Notice of Allowability

10/065,724

RAO ET AL.

FIG. 1 PRIOR ART

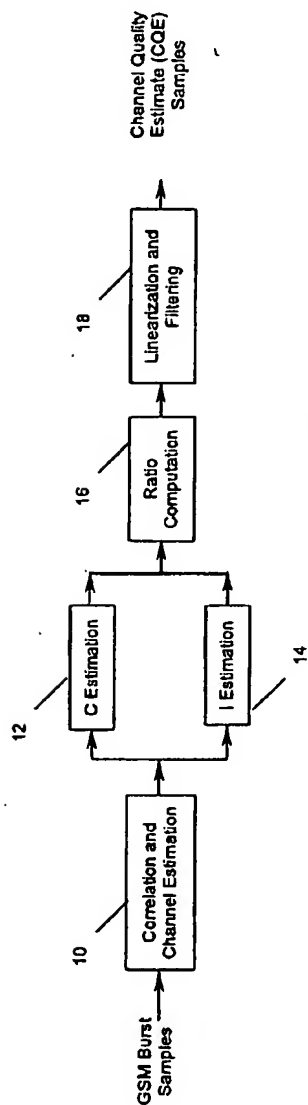
3. The examiner has made the following changes to the drawings: Figure 1 has been amended to include the label as "Prior Art." See specification in page 1. In order to avoid abandonment of the application, applicant must make these above agreed upon drawing changes.

FIG. 2

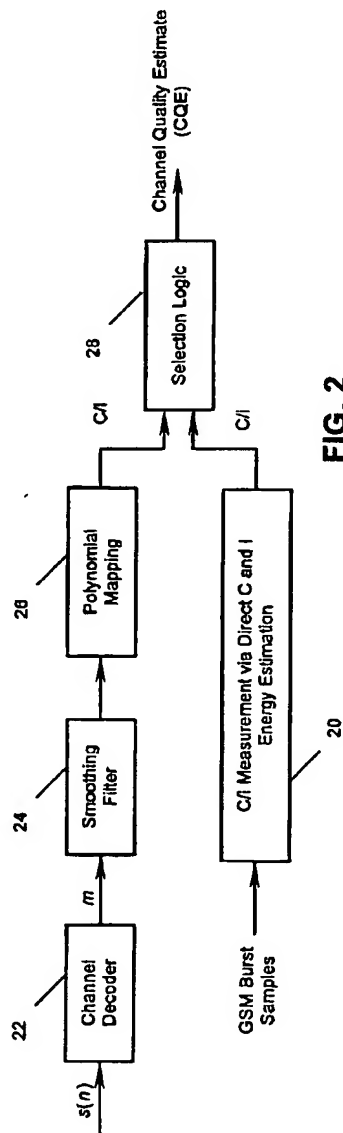
$0 < P(\text{direct}) < 1$, $0 < P(\text{metric}) < 1$, and $P(\text{direct}) + P(\text{metric}) = 1$;
multiplying $P(\text{direct})$ by the direct channel quality estimate and $P(\text{metric})$ by the decoder metric channel quality estimate; and
adding the respective products to obtain a final channel quality estimate in terms of the carrier-to-interference (C/I) ratio for the radio channel" as in claims 1 and 8. See element 28 in fig. 2 and figure 3.
